INDEPENDENT ADVISORY PANEL FOR UNDERGROUND MINING

ADVICE RE:

**DENDROBIUM COAL MINE
LONGWALL 18
SUBSIDENCE MANAGEMENT PLAN**

November 2020

Figure 2: Elouera fault location

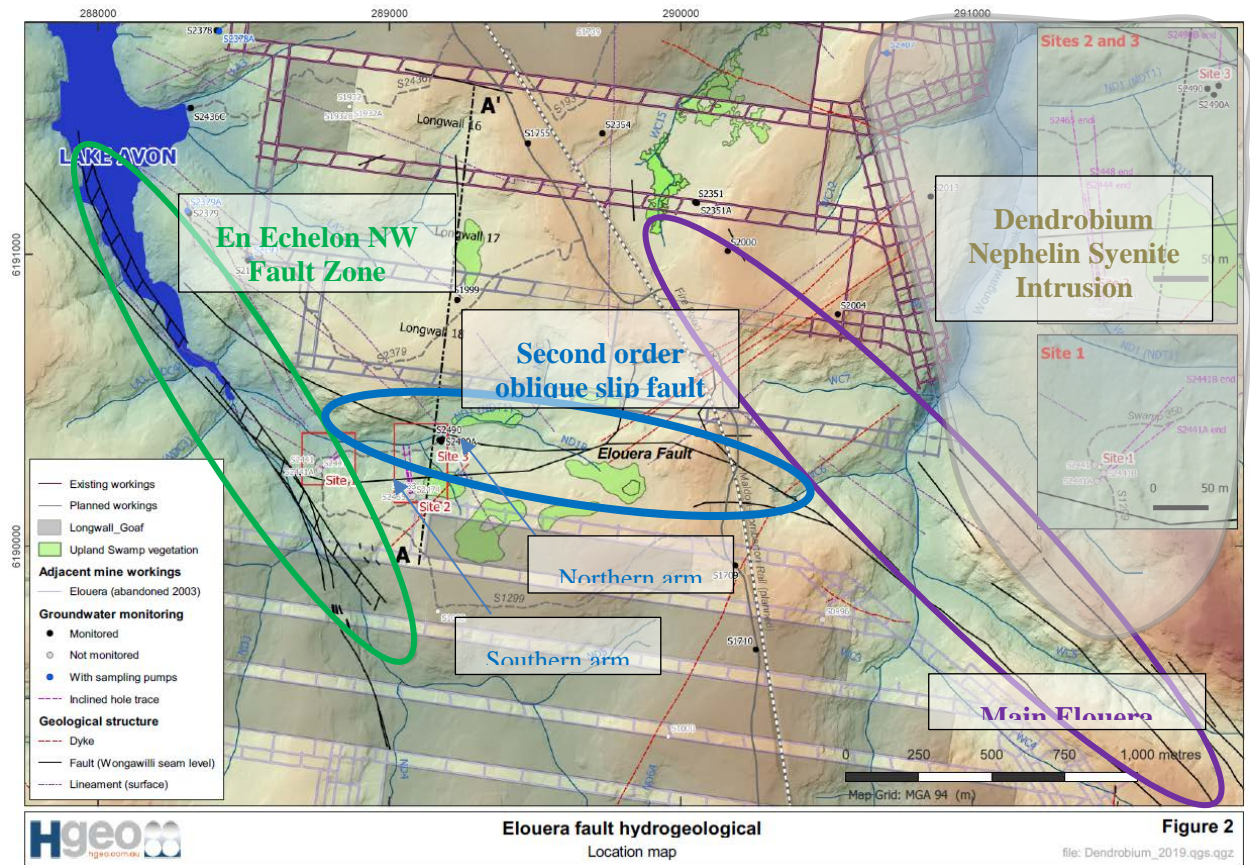
Of note is the ‘box’ structure in the mid/eastern section of the original footprint of LW18, which is associated with a geologically complex zone. LW 18 has now been shortened to avoid this structurally complex zone.

Figure 3: Avon Reservoir loss estimates (Watershed 2020 (Watershed HydroGeo, 2020)).

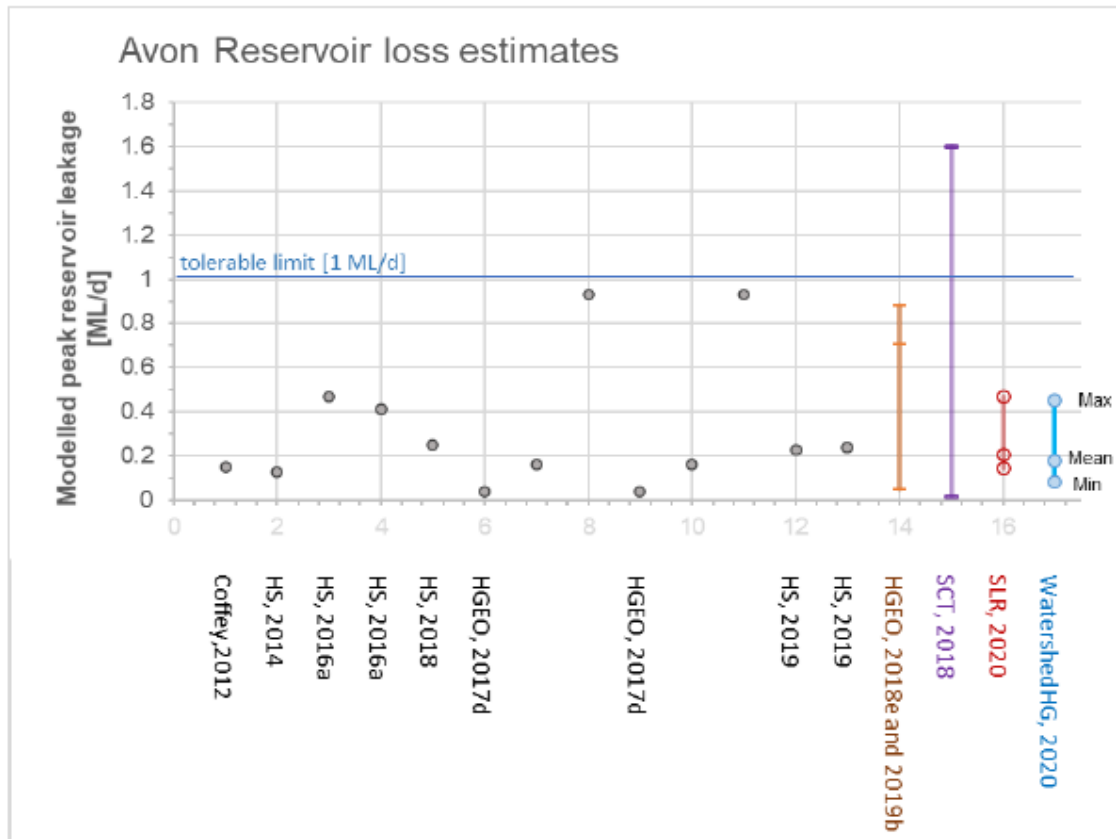
The current modelled leakage from Lake Avon as a result of all mining at Dendrobium Mine is estimated to be between 0.09 and 0.45 ML/day (Watershed HydroGeo, 2020) depending on which scenario is modelled. All scenarios fall within the prescribed tolerable limit as established by Dam Safety NSW of 1 ML/d with one exception being the range provided by (SCT, 2020). The higher end of this modelled range occurs for the higher ‘off goaf’ permeability scenario and not from scenarios that increase the permeability in the Elouera Fault (Watershed HydroGeo, 2020), suggesting the model results are not overly sensitive to fault permeability. The increase in leakage from Lake Avon due to LW18 is estimated to range between 0.01 and 0.13 ML/day.

Figure 4: Figure provided by S32 on 16/11/2020 in response to Panel query regarding the northern fault branch (DF11-N)

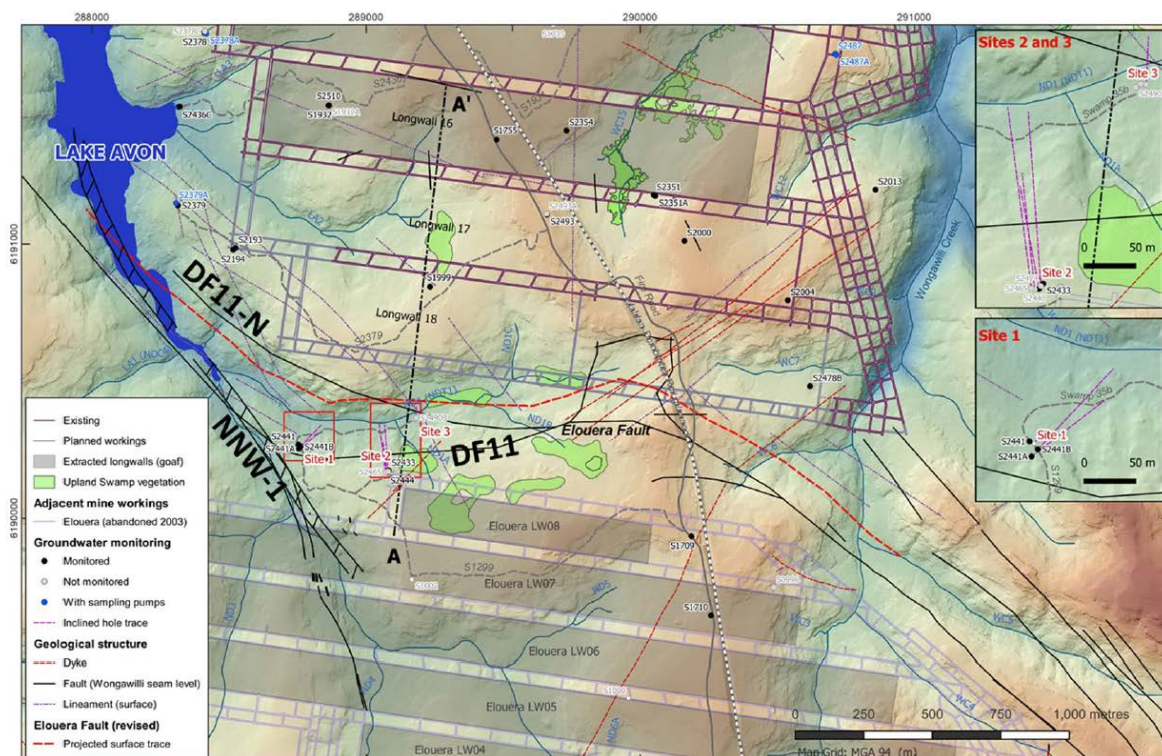
The Elouera Fault system includes branches to the south of LW18 as shown in Figure 4. The DF11 fault branch is considered by South32 to be most significant in terms of potential connectivity between Lake Avon and LW18. DF11 is 150 m from the LW18 footprint at its closest projected surface point (Table 2-3 of Watershed HydroGeo (2020)). Surface expressions of the fault have not been observed. The fault investigations conclude that, although the data show that in places the permeability of the fault zone is higher than in the surrounding hydrogeological units, the data indicate that the DF11 fault does not provide a conduit to groundwater flow.

Figure 7: Long-term (since 2013) increase in electrical conductivity at WC21 Pool.

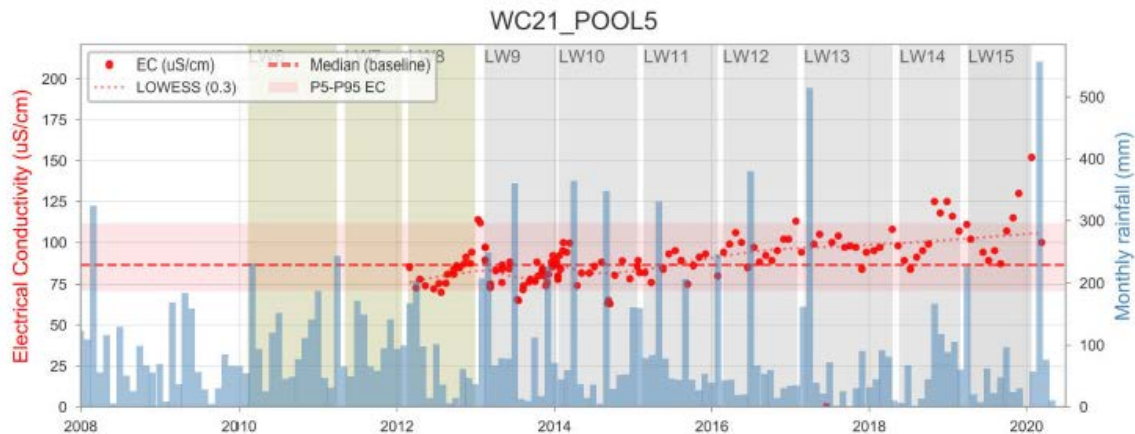
The water quality TARPs remain as in previous (2019) version of the WIMMCP. For the purpose of the LW18 SMP, the Panel has no objections to the TARPs or associated monitoring. However, going forward, the TARPs by themselves are not sufficient indicators of medium to long term trends in water quality. The TARPs are designed to identify and manage short-term anomalous extremes in water quality indicators (values greater than the 99.7 percentile). However, it is trends over periods of years

that pose the greatest risk to the water quality of the reservoirs. The issue with trends is illustrated in Figure 7, which shows the long-term (since 2013) increase in electrical conductivity at WC21 Pool5. In that case, and in general, the EOP reports include discussion of the trends and their potential significance, but there is no metric that allows trends to be easily analysed and recorded. A reporting requirement should be adopted that reports changes in trends in concentrations and also loads (flow x concentration). Consideration should also be given to the IEPMC (2019b) and IAPUM (2020) conclusions and recommendations regarding long-term, post-closure water quality risks.
